HOWARD COUNTY HISTORIC PRESERVATION COMMISSION

December Agenda

Thursday, December 6, 2018; 7:00 p.m.

This Agenda identifies the work proposed and includes comments and recommendations from DPZ Staff. The recommendations included here do not constitute a decision of the Commission.

Figure 1 - Location of house and two additional lots along Railroad Avenue

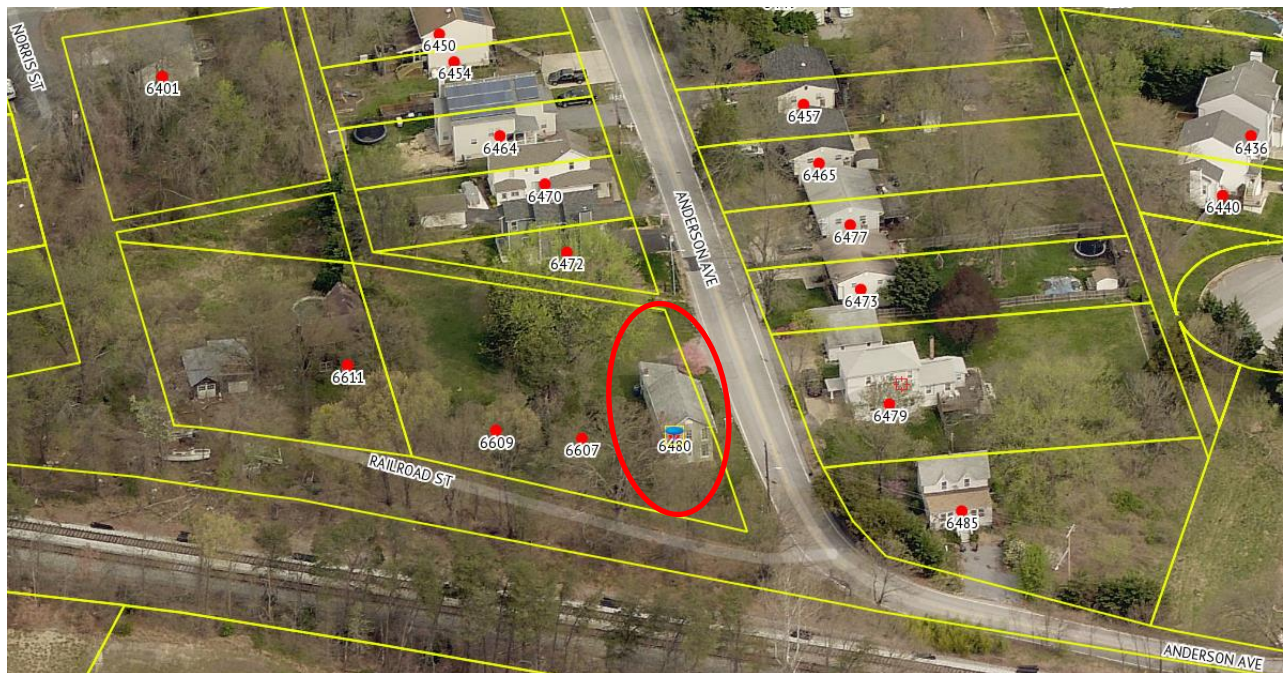
Staff Comments: As explained above, this is one of the last remaining resources for the original Village of Anderson, and was a civic building. Section 16.118 of the subdivision and land development regulations provides guidelines to improve project design, but do not prohibit demolition of historic structures. Guideline 1 states, "Historic buildings, structures and landscape features which are integral to the historic setting should be located on a single lot of suitable size to ensure protection of the historic structure and setting. If demolition is proposed, information explaining this decision shall be provided (structural conditions, cost to retain, etc.)." The application explains the reason for demolition being the reorientation of the lots for access to a public road and public sewer. However, the application does not explain why Railroad Avenue could not be treated as a pipestem lot, which is commonly seen in Howard County, so the lots could remain in their existing location and the historic house retained.

Figure 8 - Proposed footprint of house

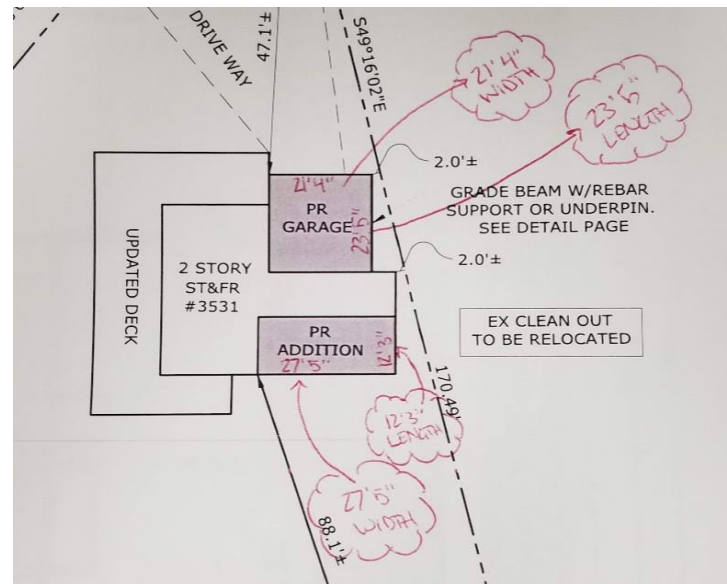
As part of the new front entry, the Applicant proposes to remove the existing front porch and ADA walkway and construct a wrap-around porch that would wrap around the north side, west side and south side of the house. The removal of the existing front porch, which is located on the west side of the property, does not comply with Chapter 6.F recommendations, which recommend against, “removing a porch or balcony that is original or that reflects the building’s historic development.” The porch and the columns, which appear original, are character defining features of this Craftsman/bungalow style home. The existing front porch has been altered over the years for ADA accommodation as seen by the ramps. The flooring is clearly not historic decking. However, the removal of the existing porch and subsequent replacement with the wrap-around porch would impact the integrity of the house. The Applicant proposes to construct the wrap around porch with Trex Transcend composite decking in the color Island Mist, Trex Transcend railings in the color classic white and PermaSnap cPVC column wraps in the color white. The removal of wood columns and railings does not comply with the Guidelines, which recommend, “if the porch is integral to the design of the building, replace it with a new porch similar in style, scale and detail.” The proposed Trex decking would be more appropriate for a rear deck, but are not appropriate for a proposed wrap around porch, or as a replacement decking for the historic porch (if retained). This house, similar to others in Ellicott City, most likely had a painted tongue and groove wood porch. Chapter 6.F explains that “materials generally not appropriate for historic porch replacements include unpainted pressure-treated wood, poured concrete and metal.” The Guidelines pre-date the use of Trex and other composite deck materials, but in general, Trex would not be seen as a replacement that, per Chapter 6.F of the Guidelines, is “similar in style, scale and detail.”

The proposed columns for the new wrap around porch will be pressure treated wood wrapped in the PermaSnap column wrap. The size of the columns was not specified, but from the renderings it does not appear they will match the size and design of the existing columns, shown in Figure 15. Overall, the removal of the existing historic front porch and construction of the new porch does not comply with the Guidelines. However, adding a porch to the south side of the house (which is the side but appears to be the rear) facing the railroad tracks and river would comply with the Guidelines as it will not be visible from the public right of way. Chapter 7.B states, “porches or decks added to historic buildings should be simple in design and not alter or hide the basic form of the building.” The porch as proposed would alter the form of the building, but if only added to the south side of the building facing the river, would not alter it.

The proposed garage will be constructed on the north side of the house facing the street. Although this side faces the street, it is actually the side of the house. The garage design incorporates a Craftsman/bungalow style panel and window arrangement, which matches the design of the proposed door. It appears there will need to be some grading in order to construct a driveway to the garage without an extreme slope and more information is needed on how much grading/excavation will be needed and whether or not retaining walls will be needed. The material of the driveway is unknown.

The proposed rear addition will be located on the south side of the house, facing the railroad tracks/Patapsco River. While referred to as the “rear”, this is actually the side of the house. The wrap around porch will continue on this elevation along the existing structure, but will not continue around the addition. The addition will be two stories in height with several new windows, as shown in the drawings. The addition will be 27’5” feet wide by 12’3” long. The addition will use the HardiePlank siding to match the house and the proposed Integrity black fiberglass 1:1 windows. The proposed rear addition complies with Chapter 7 recommendations, “attach additions to the side or rear of a historic building to avoid altering the primary façade.” The roofline will change substantially as this is proposed to be a two-story addition and will change the look of the front of the house as a result (front being the side view from the west). However, given the constraints of the lot and the siting of the house, the addition will not be highly visible and the south side of the house cannot be seen when looking at the house from the public right of way.

Staff Recommendation: Staff recommends this application be amended to Advisory Comments, with the following recommendations for the Commission to consider:

- 1) Approval of the roof, subject to submittal of an appropriate spec sheet, of a gray roof.
- 2) Alternate windows, such as a clad wood in a 3:1 or 6:6 pattern be used.

- 3) Approval of the use of HardiePlank siding, on the garage and addition be used.
- 4) Denial of new “front” door on the north side of the house.
- 5) Denial of new “front” porch on the north side of the house.

- 6) Approval of the proposed Craftsman style fiberglass door for use on the actual front/west side of the house, but tax credit pre-approval if a wood door of the same style is used.

- 7) Approval of the construction of the garage on the north side of the house.
- 8) Approval of relocation of the electrical panels.
- 9) Approval of the demolition of the deck on the north side of the house facing the street.

- 10) Approval of the demolition of the ADA walkway and ramp on the north/west side of the house.
- 11) Denial of the proposed demolition of the historic front porch on the west side of the house.

- 12) Approval of the proposed rear addition.

Figure 17 - Location of preserved land in Lawyers Hill

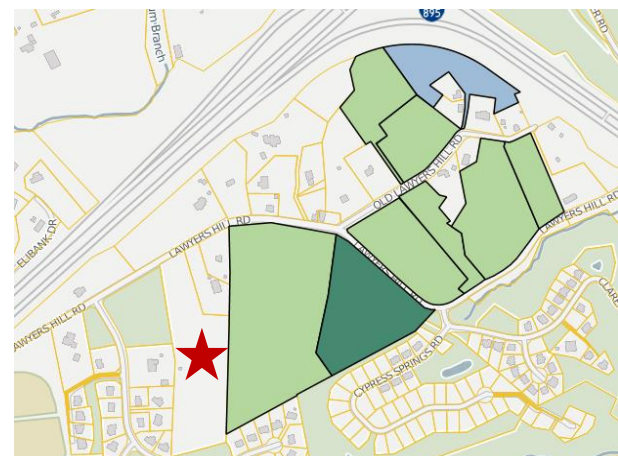
This goal has been supported through voluntary land easements that many property owners have added over the years. The easements in Lawyers Hill include Rockburn Land Trust easements, Conservation easements, Maryland Environmental Trust easements and Maryland Historical Trust easements (easements are shown in Figure 17 in green and blue, and the subject property is shown with a red star).

Figure 18 - Photos of existing homes in Lawyers Hill

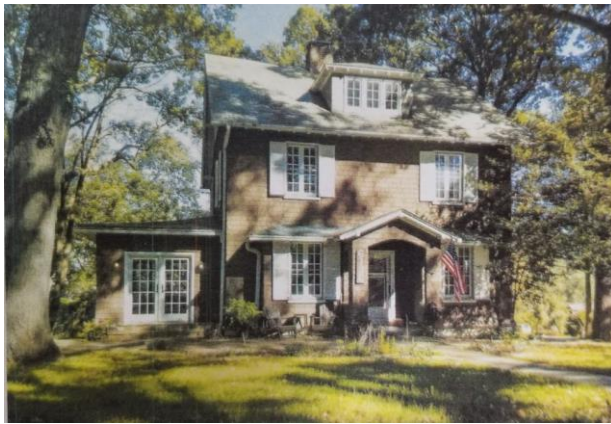
The photos of the proposed homes show a mix of brick or stone veneer facades with siding on the sides and rear. They include multiple siding materials and features such as multiple gable pitches within a single roofline. While these design features may not be compatible with historic homes in Lawyers Hill, the Guidelines explain that “new homes need not attempt to replicate historic styles. However, to preserve the historic character and value of the district, new buildings visible from the District’s public roads should be compatible with the form and scale of the historic homes.” While the proposed homes are not consistent with this recommendation, their individual elements may be. The HPC should, therefore, provide advice on elements that could be considered consistent.

Staff Recommendation: The HPC should consider requesting additional details regarding which home model or elements of each model are proposed; the number and location of trees proposed for removal; and the proposed layout and siting of the individual houses.
